OCP NIC 3.0 Design Specification

Version [0.600-58](#)

Author: OCP Server Workgroup, OCP NIC subgroup

Figure 1: Representative Small OCP NIC 3.0 Card with Quad SFP Ports

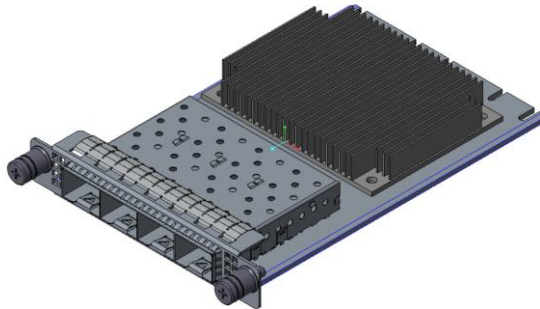
Commented [YL5]: To avoid confusion, I would recommend adding more clarification here – 80W for small card and 150W for large card is from power/connector point of view. System needs to evaluate whether they can provide sufficient airflow to cool it thermally.

Adding more data and simulation analysis in thermal session (7.1) for reference.

Figure 6455: Add-in Card and Host PCB Thickness Options for Straddle Mount Connectors

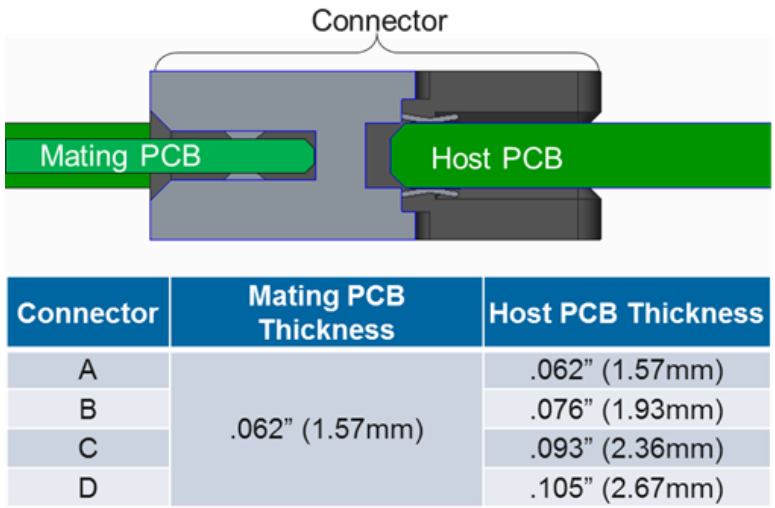
Commented [CP25]: +/-8% for all thickness would have cost impact. Need feedbacks from PCB and connector vendors. May be 8% for thicker (>=0.093) boards and 10% for others?

[Figure 7667](#): Single Host (1 x16) and 1 x16 Add-in Card (Single Controller)

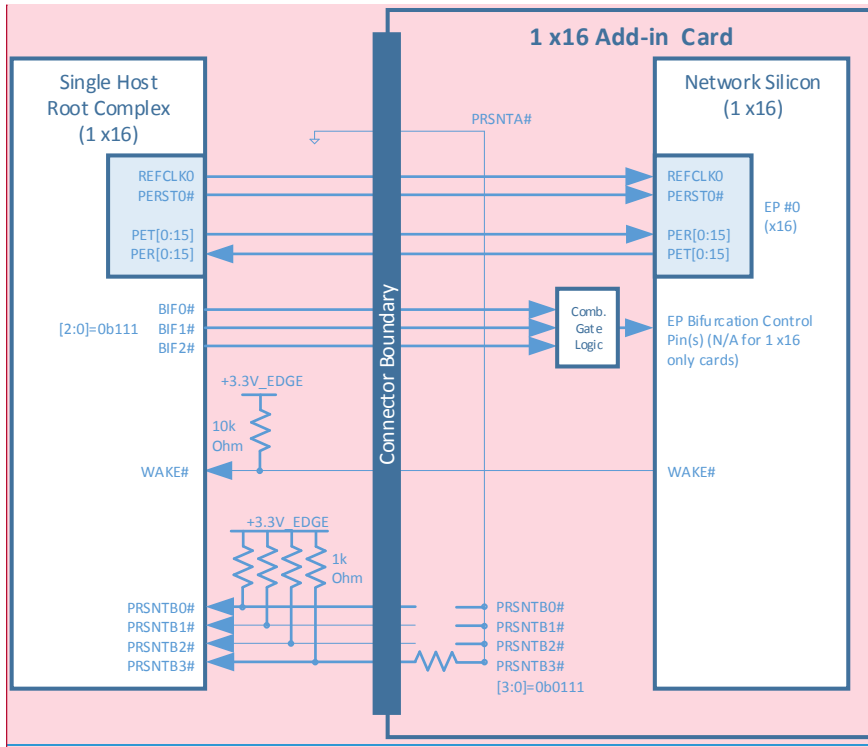
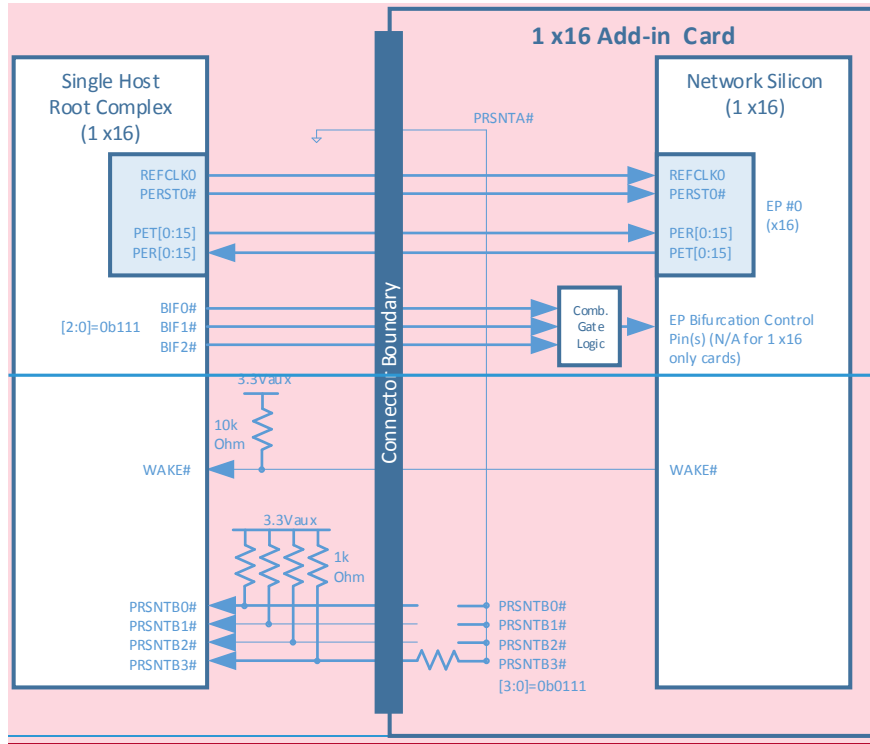
Commented [NT39]: From Jon Lewis:
 I think the resistor strap is wrong... you can change 3:0 to 0:3 or move the resistor. (Figure 67 from v57)

Figure 85: Power-Down Sequencing

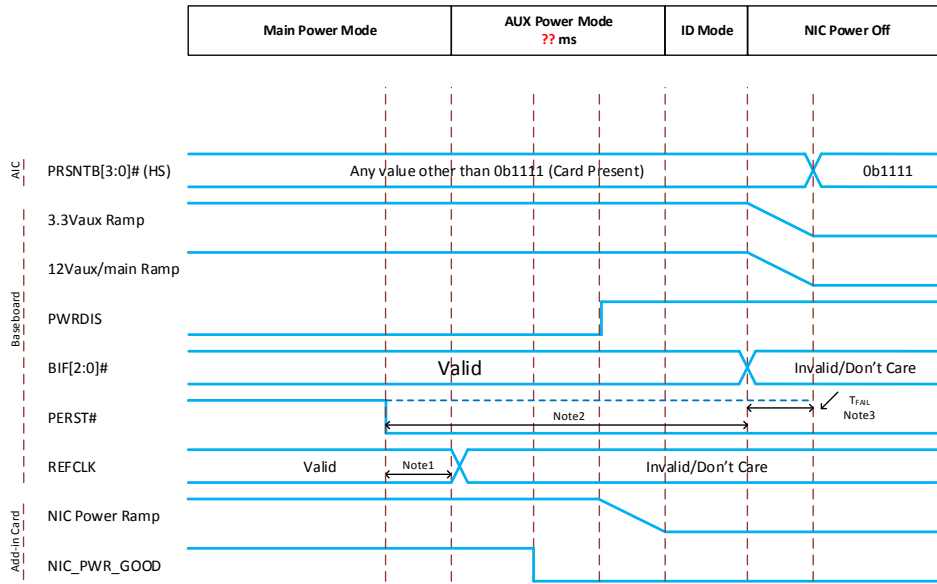
Commented [CP55]: PWRDIS should be low during G3 mode, as specified in table 37

Figure 87: Thermal Simulation and Design Guidance for S5

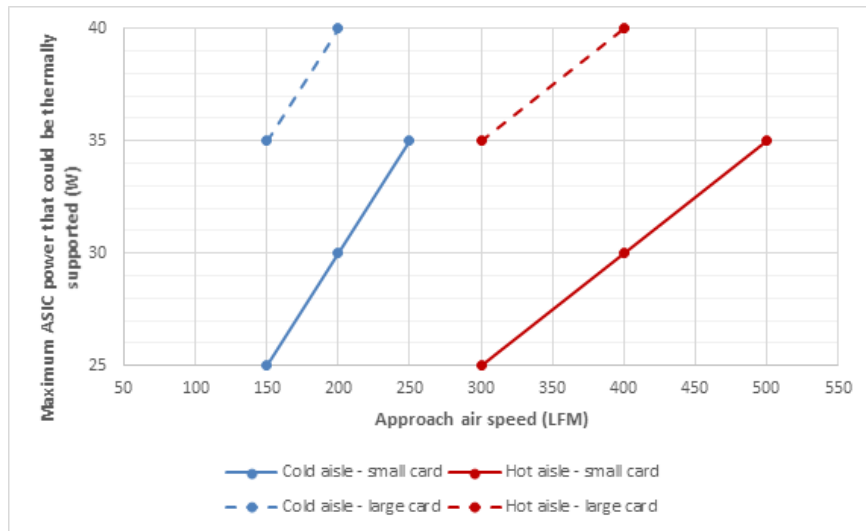
Commented [YL80]: Needs to be finalized (55C/60C) Discuss with Rob (Dell) and Paul (HPE)

Commented [YL81]: More informative using charts. Table can be removed after charts are finalized.
